RE: PRISM Engineering's "Traffic Engineering Review" of 253 South Los Robles Project and Related Traffic Issues

TRAFFIC ENGINEERING REVIEW

253 SOUTH LOS ROBLES PROJECT AND RELATED TRAFFIC ISSUES

City's Traffic Model TAZ Structure.

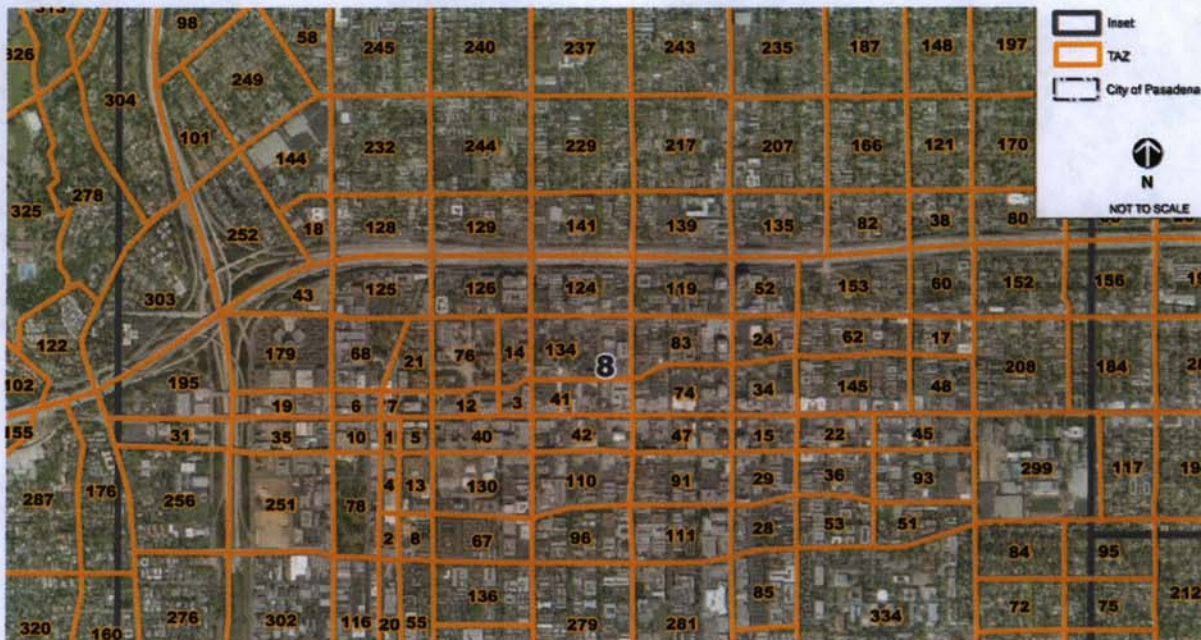
In the graphic below, taken from the PASADENA TRAVEL DEMAND FORECASTING MODEL DEVELOPMENT REPORT appendix (see link below), it can be seen that the 253 S. Los Robles proposed project would be in TAZ #67, and would represent only 5% of the total content of that zone. This TAZ 67 is large and includes two blocks of existing development bounded by S. Los Robles on the east, Cordova on the north, E. Del Mar on the south, and Marengo on the west. With this arrangement, the 253 S. Los Robles project could just as easily be directly assigned in the model randomly to any one of the four "block" faces of the TAZ.

This is not anywhere near precise or accurate enough to utilize model-generated turning movements at an intersections, or project trip distribution assignments for the very small 253 S. Los Robles project that is contained within a very small part of TAZ 67. The project is literally only 5% of the TAZ 67 total land uses, trip assignment is 95% influenced by the other land uses in the TAZ, and S. Euclid Ave even splits TAZ 67, so that the project could even potentially be assigned in the model directly to Marengo, let alone Cordova or Del Mar, which would not be correct.

TAZ 67 is very large, two blocks, part of a macro-level model. A micro-level model at the parcel level is necessary in order to have appropriate use in assigning traffic from potential projects. Since this level of parcel-based TAZ precision does not exist in the City's model, the model should not be used for assigning

“Friction Factor Curves” in the City’s Traffic Model

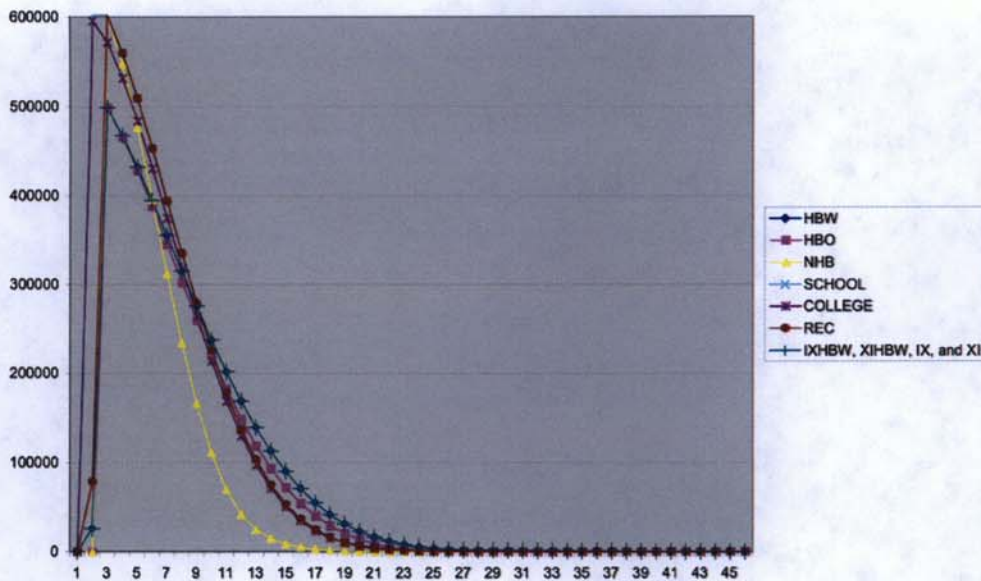
This assumption in the model, the "Friction Factor" curves (see figure below), represents how "attractive" (according to the "gravity model") a trip will be based on how many minutes it takes to get from one TAZ (traffic analysis zone, see orange boxes in figure above) to another. Notice that ALL trip categories and their curves are essentially the same values, which is not logical. All curves closely follow each other, the HBW curve (home to work), the School curve, etc. making different kinds of trips in the model no more attractive than the others... but in the real world, work trips are generally very long as most people don't live next to their place of employment, but school trips are much shorter, even neighborhood based where the child lives, as most neighborhoods have access to a nearby elementary school (that facilitates the possibility of walking).

In the figure above for friction factor curves⁸, the way to interpret this chart is to first look at the bottom axis which represents minutes of travel. It can be seen that a 20-minute trip is near to the point at which all curves flatten out at zero (no longer attractive). Slightly over 20 minutes of travel time in the model there is zero "attractiveness" and so a 25-minute trip would never be assigned. Long trips are not possible. A 10-minute trip would have a friction factor value of about 220000. A 5-minute trip has a corresponding value of about 450000 for most curves. This means, a 5-minute trip in the model will be at least twice as attractive as a 10-minute trip. More traffic will be assigned from one TAZ 5 minutes away from another nearby TAZ (five minutes of travel time away).

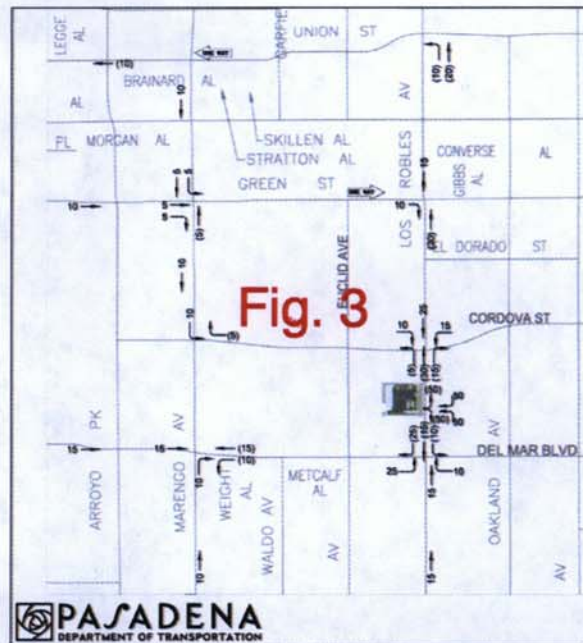
The traffic study showed a project traffic assignment as follows in the clip from Figure 3 of the report (below). Anecdotal information from residents who drive S. Los Robles on a regular basis indicates that there are currently long lines of traffic that back up on S. Los Robles in front of the proposed project site, and that the assumptions shown in Figure 3 could not happen, as there will not be a gap in traffic for project traffic to get out in the morning.

50% of the project traffic was assumed in the DOT study to make a left turn out of the project, presumably because the travel demand model showed this.

A closer look at the figure shows project traffic patterns that raises questions... such as 50% of the project turning left out to go north on S. Los Robles in the morning when there are long lines of northbound traffic already on the road that would prevent this from being reasonable/possible (no sufficient gaps in traffic).

For these kinds of reasons, manual assignments of traffic, by a traffic engineer, should have been performed so that trip distributions are reasonable, and project impacts can therefore be properly analyzed, based on real world engineering judgment of what is possible/reasonable.
